Remarks
Of the Republic of Poland
as:
the state of registration and operator

on the draft Final Report
regarding
the investigation into the accident of the Tu-154M tail number 101 aircraft
which occurred on 10 April 2010
drafted by
the Interstate Aviation Committee (IAC)

Warsaw, 19 December 2010

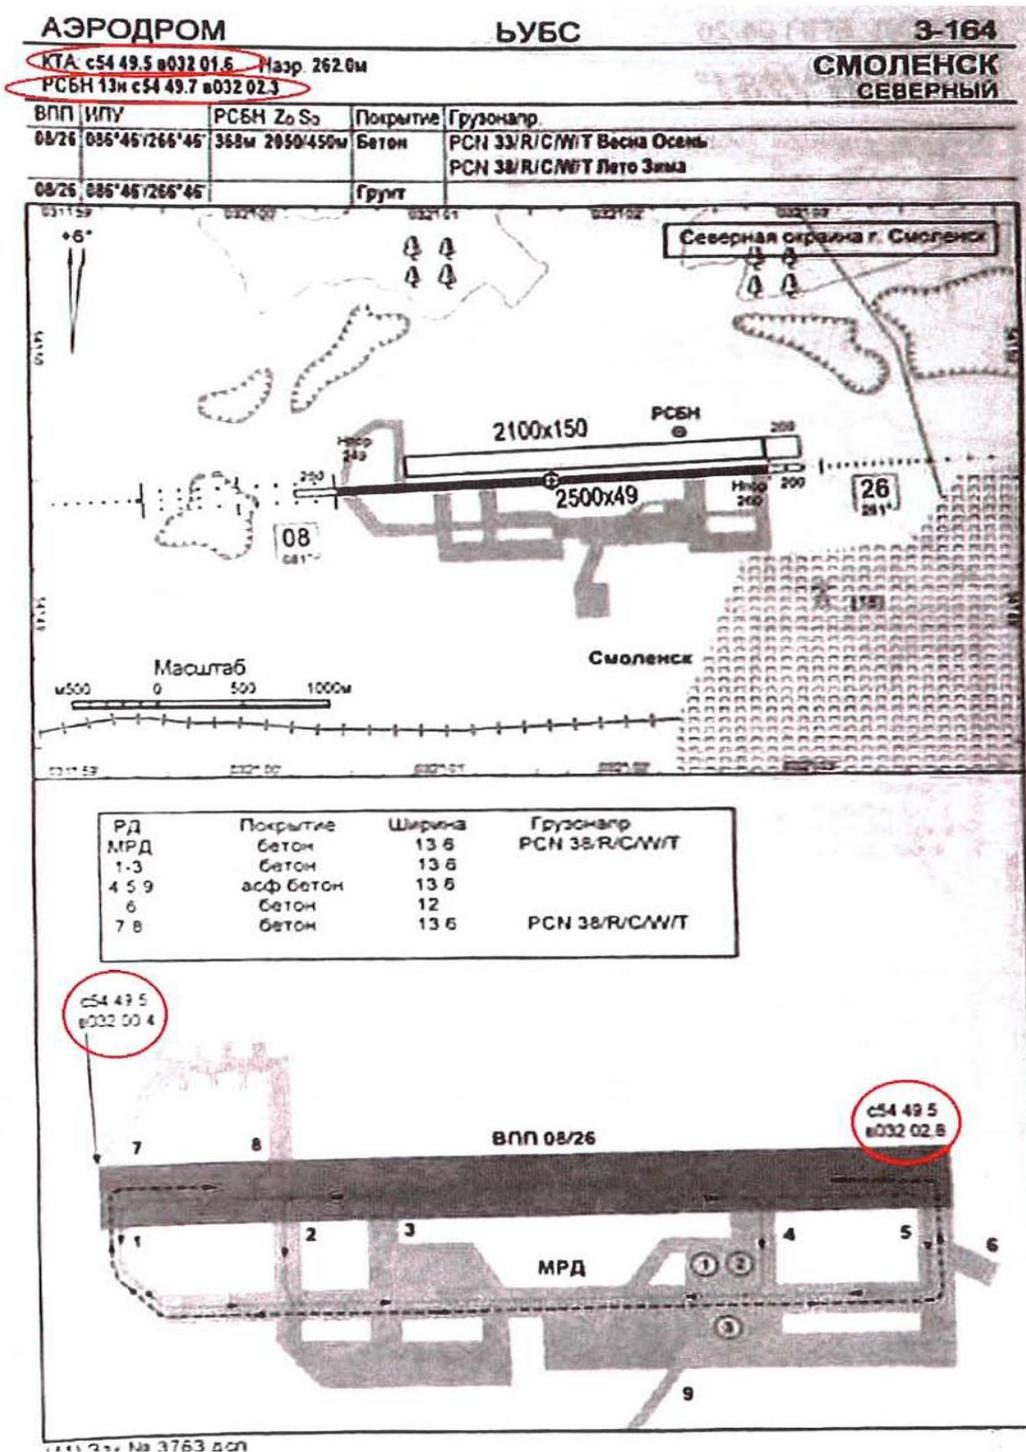
1) regarding the aerodrome description contained on page 67 of the Report:

According to the Russian side, Smolensk “Severny” aerodrome met the requirements of Class 1 aerodrome (*“Technical Review Act of Smolensk “Severny” aerodrome with the purpose of special flights”* of 5 April 2010). The data provided on the aerodrome are actually unverifiable for the Polish side, due to the fact that the Russian site failed to provide source materials, including: *“Flight operation manual for the aerodrome”*, *“aerodrome Master Plan”* and/or similar documents. The Report does not provide detailed schematics of the aerodrome, the display of restricting area and the cross section along the axis of the runway as well as the approach areas surface. The Russian side failed to provide the Polish side with any materials or legislation, defining the classification rules for state aviation aerodromes and military airfields requirements for each class. This prevents the Polish side from comprehensive verification whether the required parameters for class I military airfields had been ensured for Smolensk “Severny” aerodrome. This in particular regards the restricting area, which is determined for each aerodrome in order to ensure the safety of aircraft traffic operating on aerodromes and which defines the maximum allowable height for buildings and terrain objects, located in the vicinity of the aerodrome. Objects which parameters exceed the values defined by the above mentioned area should be removed, or (in case of inability to remove) should be identified as air traffic obstacles and marked accordingly.

The available information indicates that the data on the aerodrome provided to the Polish side, including the coordinates of the ARP, runway threshold coordinates and the coordinates of the outer and middle NDB aeriels (all coordinates on the approach chart), are expressed in the SK-42 coordinates system and not in currently generally accepted for aviation WGS-84 system. The Polish side was not informed about this fact by the Russian side upon submission of the approach charts by the latter.

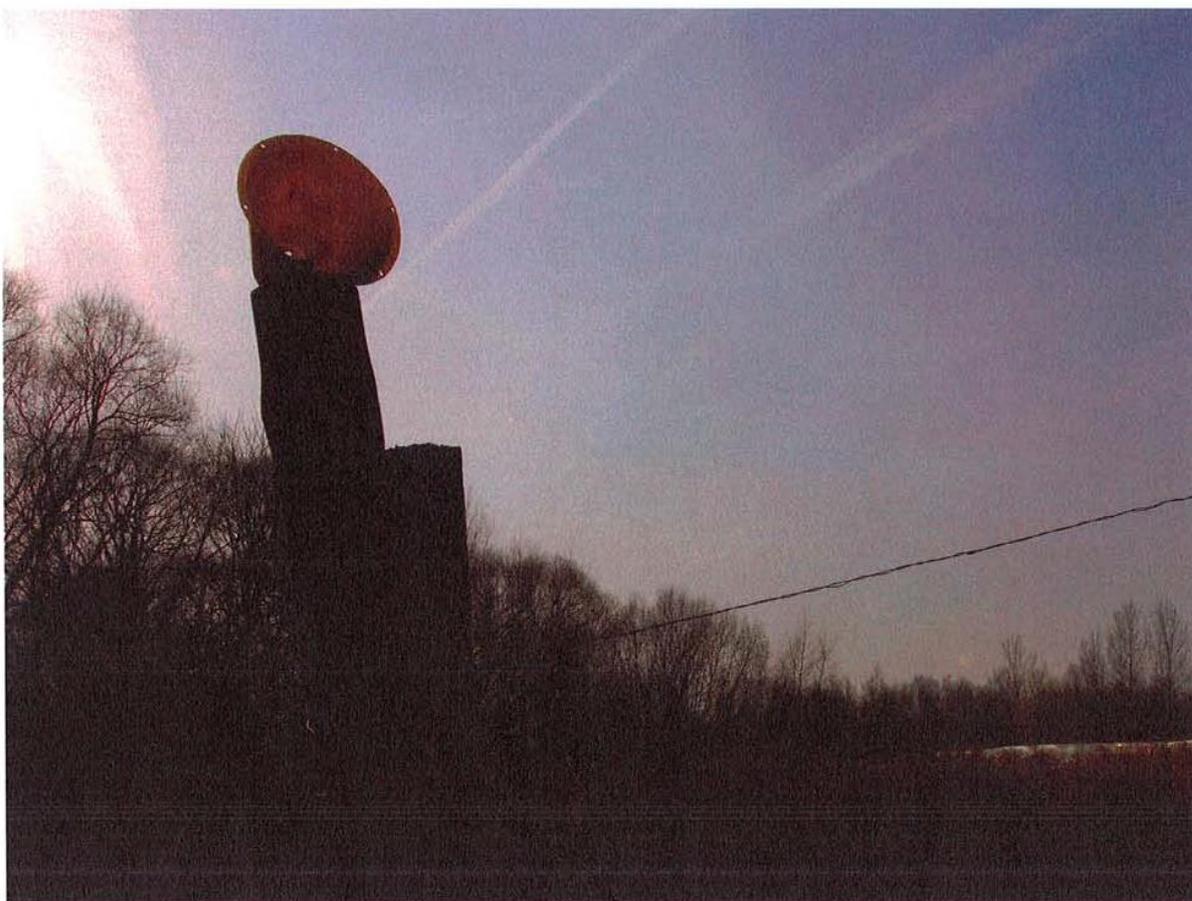
Location of the blip on the indicator corresponds to the position “on the glide path” when the permissible error of linear deviation does not exceed 1/3 of the linear dimensions of the zone of tolerance”. (in accordance with paragraph 115 of FAPPPGosA)

For the path of 3°10' at a distance of 3.3 km to the DS26 the permissible error of linear deviation is ± 28 m, i.e. with a tolerance of 1/3 of the value that is below - 9.33 m, KSL should have informed the crew of its wrong position on the path. The conclusion is that even before reaching 3 km, KSL continued to inform the crew of their correct position “on the course and path”, when in fact the flight of the aircraft was lowering, increasing its vertical distance from the path.

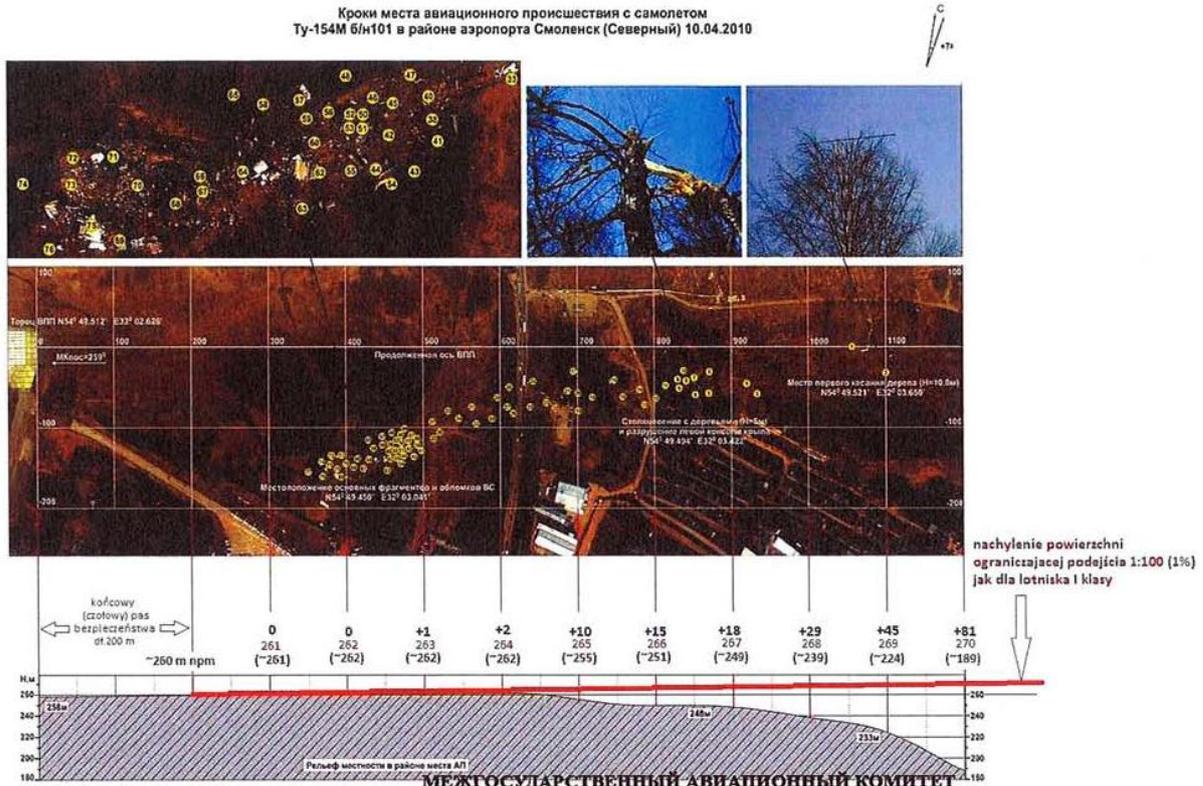
- surface stretching from the end of the Final (lead) Safety Strip (KPB), i.e. 200 m from the 26 threshold;
- width of the initial (internal) margin 124 m;

- separation of side margins 15°;
- slope 1:100 (1%);
- initial ordinate 260 m above sea level (due to the elevation of the surface of the KPB relative to the 26 threshold).

OPTION II

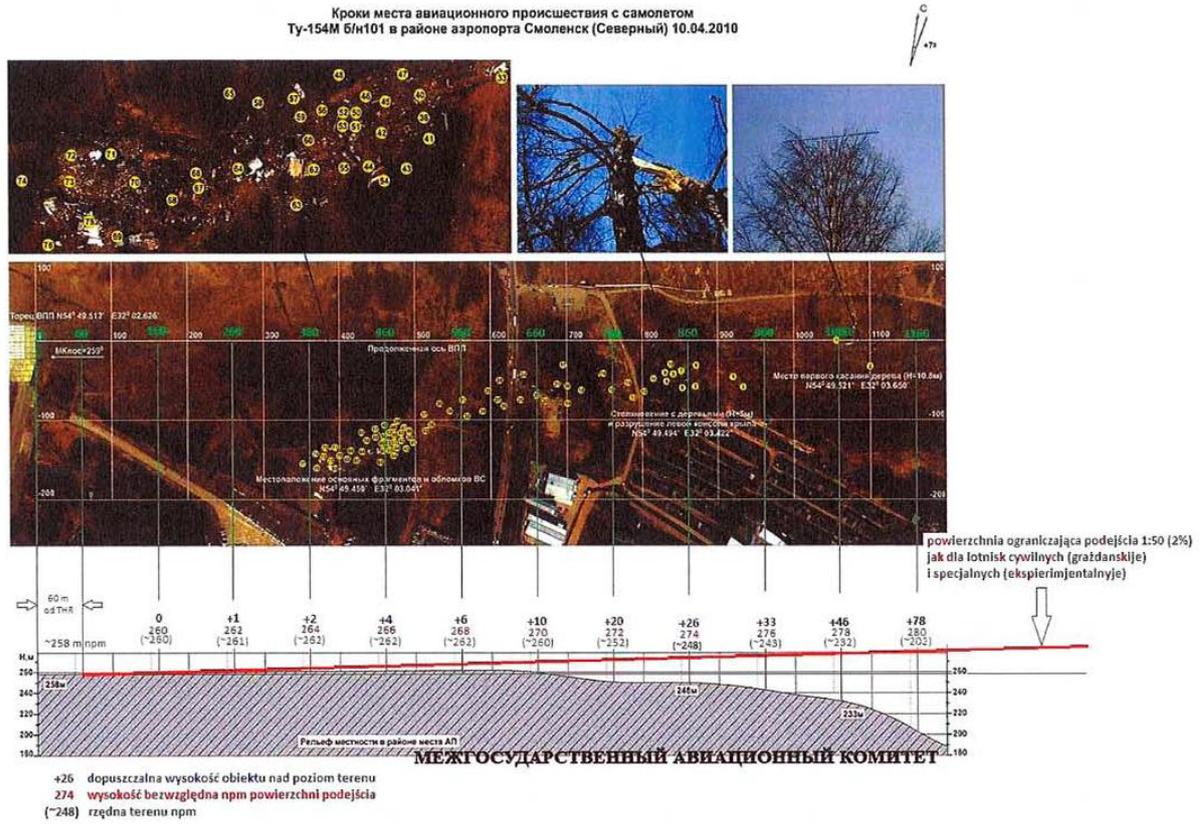
Initial data of the approach surface:

- surface stretching 60 m from the 26 threshold;
- width of initial (internal) margin 300 m (150 m from the DS axis);
- separation of side margins 15% (app. 8.5°);
- slope 1:50 (2%);
- initial ordinate 258 m above sea level (height of 26 threshold).

Logged trees and shrubs at the approach axis, at app. 700 m distance from the DS 26 threshold.

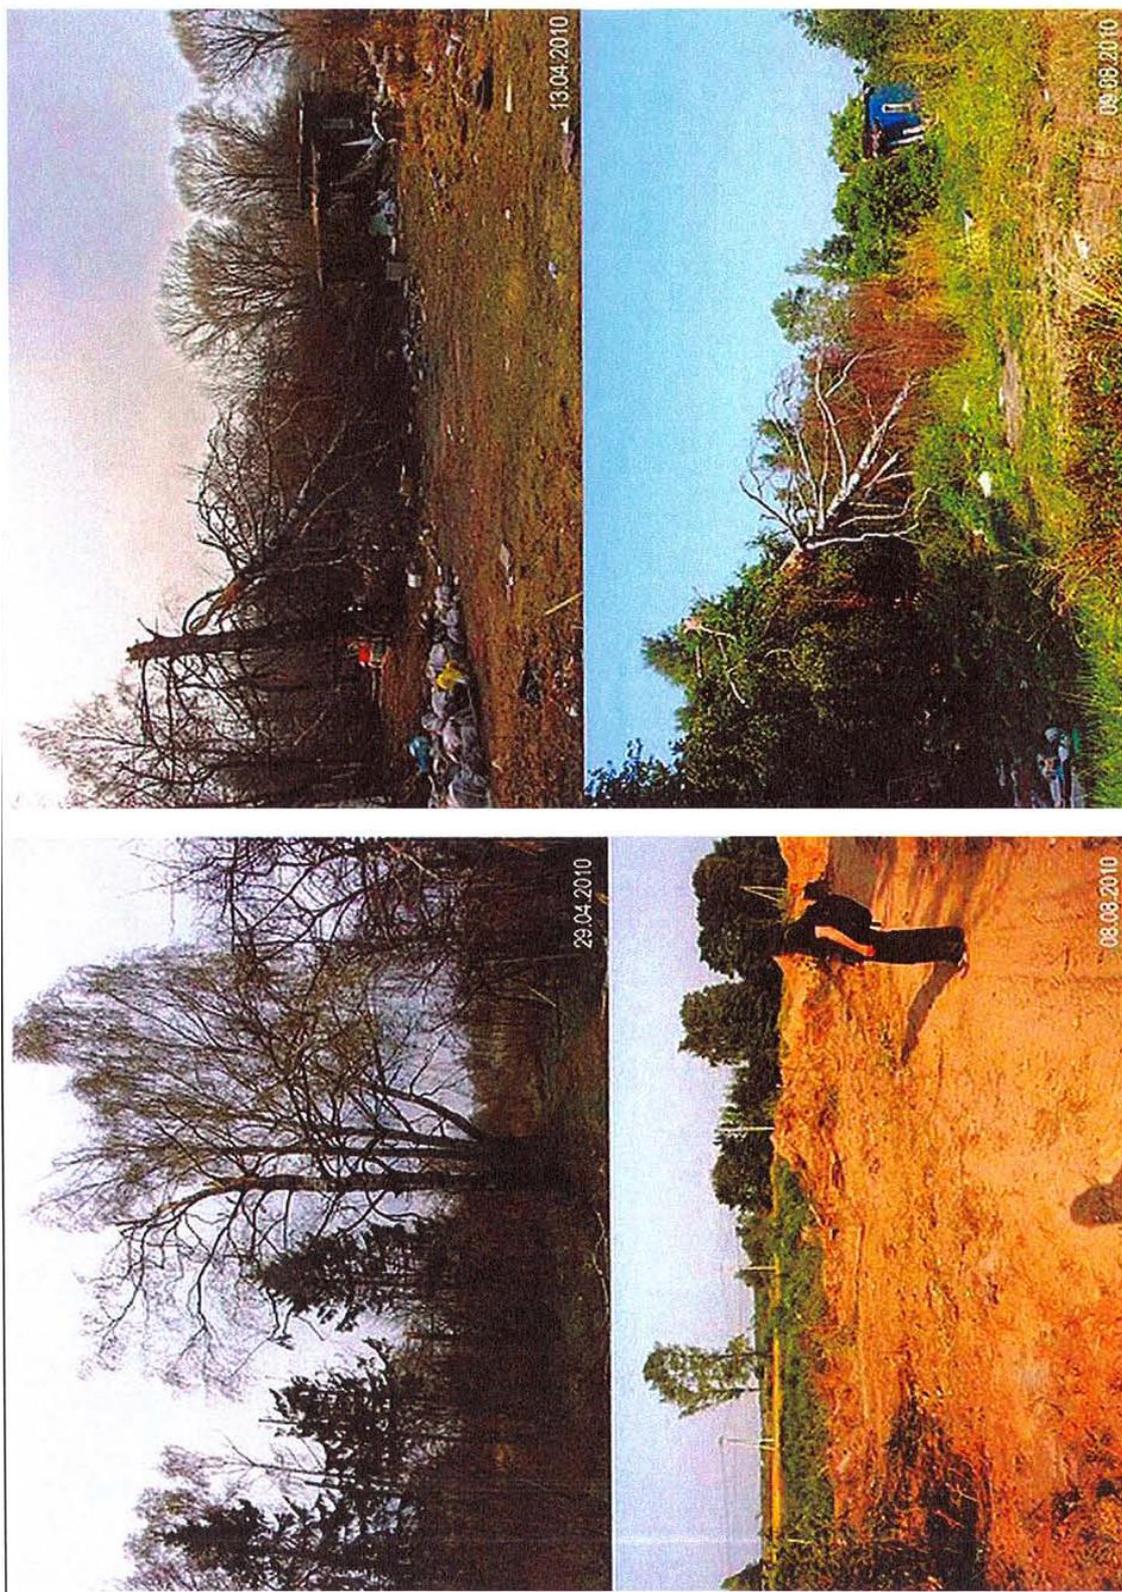
This is inconsistent with the Polish, Russian and ICAO (Annex 14) regulations. These clusters of trees in question constituted a real threat to aircraft approaching for landing on the DS 26, especially in the difficult weather conditions that prevailed on 10 April 2010. Moreover, the trees and shrubs growing in the area before the DS 26 threshold obscured lights from the lighting system for the crews and limited SKL personnel's already obstructed visibility (due to fog) from SKL toward the 259° approach. In these circumstances, one cannot claim the aerodrome was fully operational and ready to accept aircraft, particularly those of HEAD status. It should be noted, that *"The act of technical review of the Smolensk "Severny" aerodrome to accept special flights"* dated on 5.04.2010, merely states that, quote: *"... at a distance of 1 to 4 km from the runway threshold, there are no obstacles measuring over 10 m in height relative to the runway threshold and from 4 km to the end of the approach strip, measuring 50 m relative to the runway threshold"*. No information is given about any possible obstacles situated at a distance of up to 1 km from the DS 26 threshold, i.e. in the area where representatives of the Polish side had found clusters of tall trees. The Polish side's assessment of the forest stand having exceeded permissible height levels along the DS 26 approach is confirmed by the mass logging of trees and shrubs in that area, which took place after the accident, as had been established based on the available photo documentation (picture below).

Logged trees in the BRL area app. 900 m from the DS 26 threshold

Differences in condition of the forest stand - area of the approach axis next to the motorway app. 600-650 m from the DS 26 threshold.
